Site monitoring report

Site Name: Highwood Quarry, Stortford Road, Little Canfield

File Ref: 11 421 33

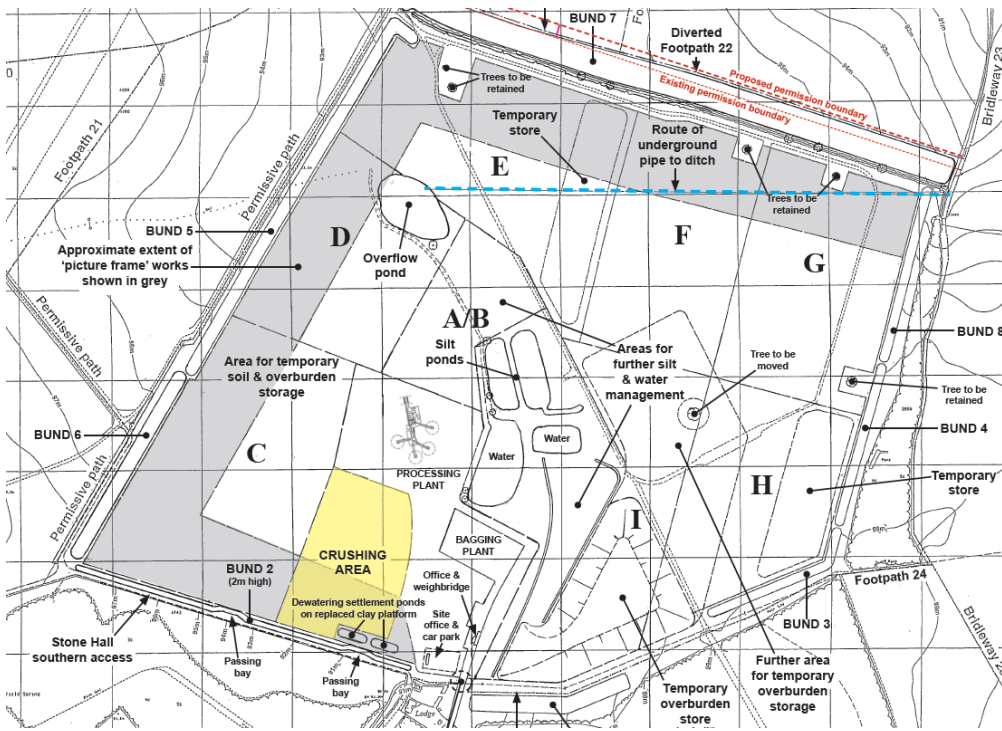
Extraction completed on NW section of access track, EQA report sent to EA re lining of site for boundary of D and E.

Extracting in phase G and landfilling in G, also extracting in south of phase H, with topsoil being stripped in south section of G.
